Proposed Permit Modification Requests

Proposed Class 2 Permit Modification Requests (PMRs)

- Update Ventilation Language
- Addition of a Shielded Container
- Revise the WIPP Groundwater Detection Monitoring Program Plan

CURRENT

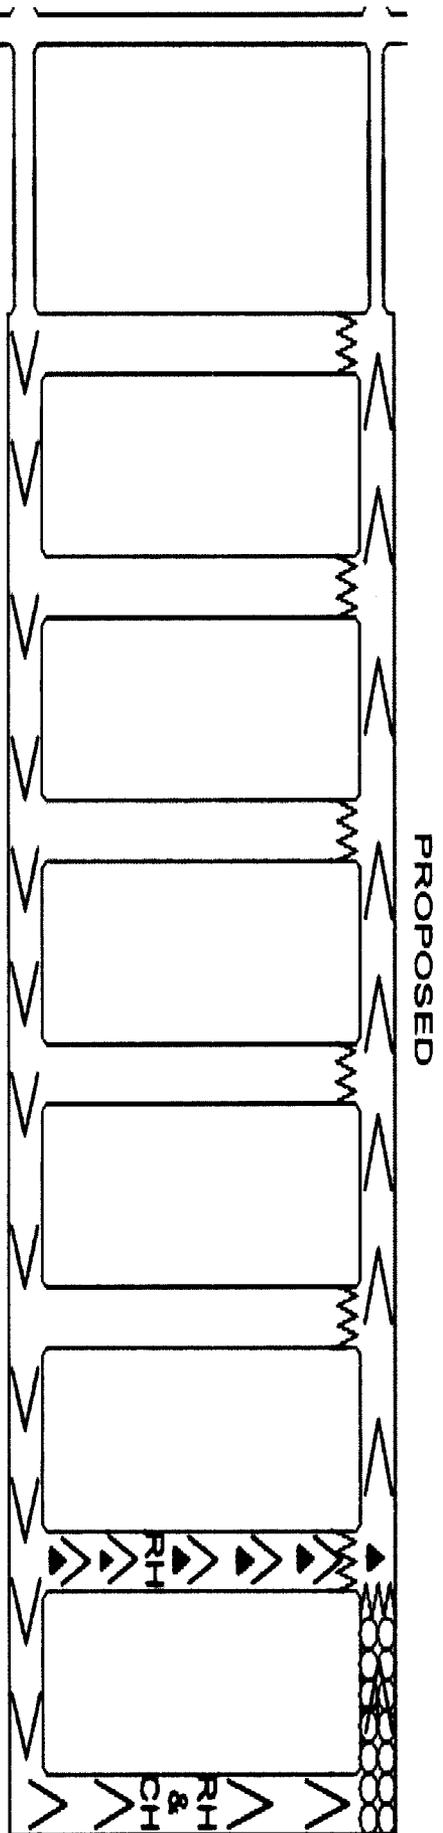
- Propose that workers are permitted to enter active rooms that are not adjacent to a filled room with ventilation $< 35,000$ scfm in order to perform activities such as geomechanical monitoring, adjusting ventilation regulators, perform ground control inspections, or RH equipment maintenance.

Addition of a Shielded Container

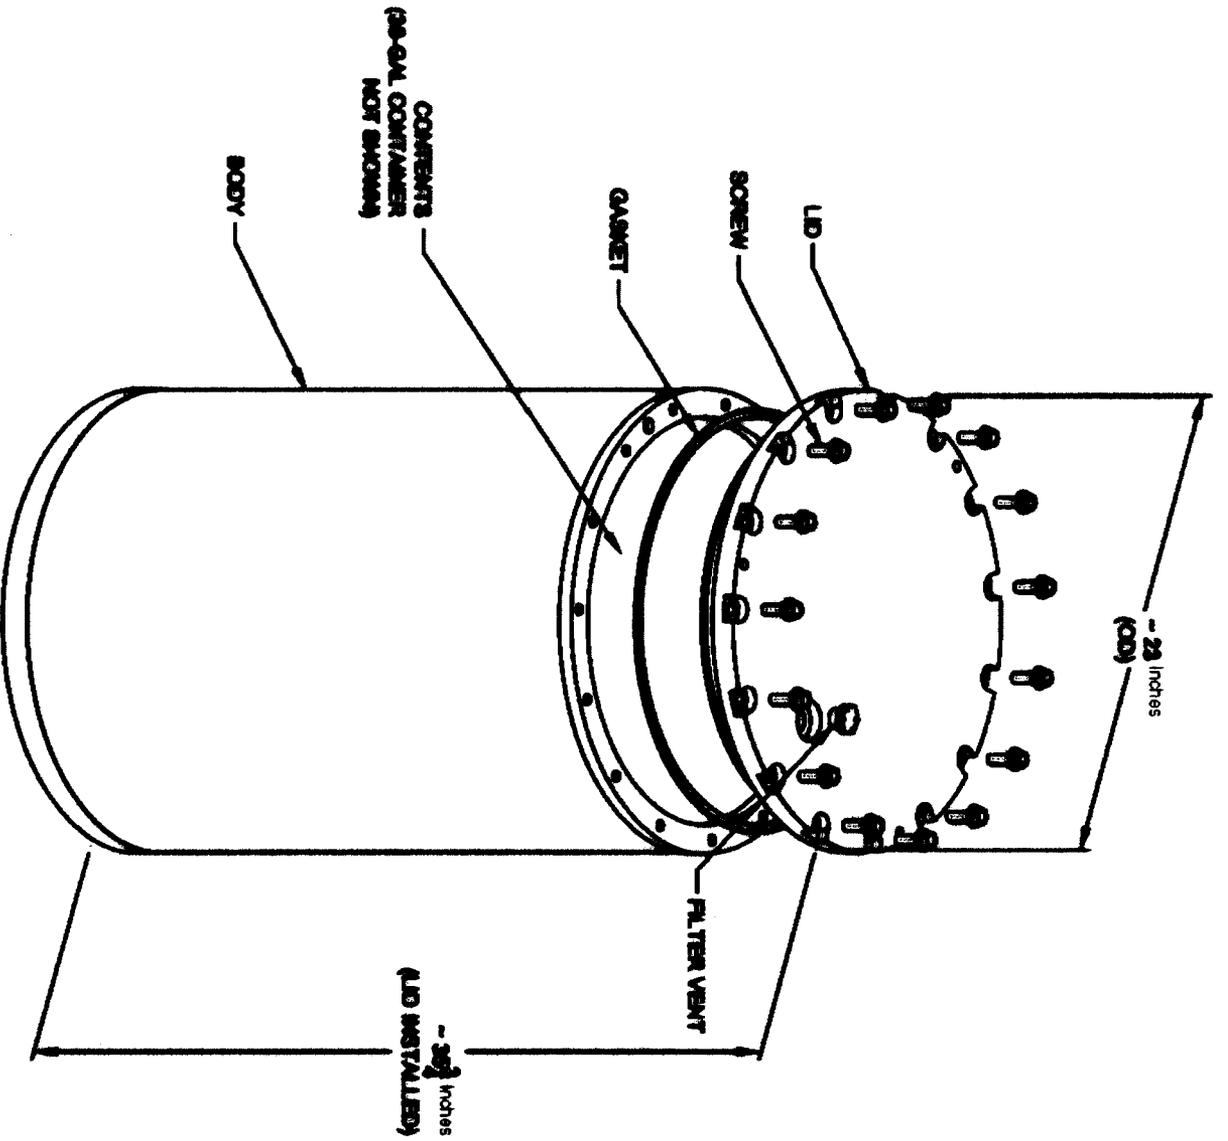
- The changes in this PMR are the following:
 - Addition of a new gamma shielded container for managing RH TRU mixed waste
 - This waste will be managed as CH TRU mixed waste, but will be counted towards the allowable RH TRU mixed waste repository limit
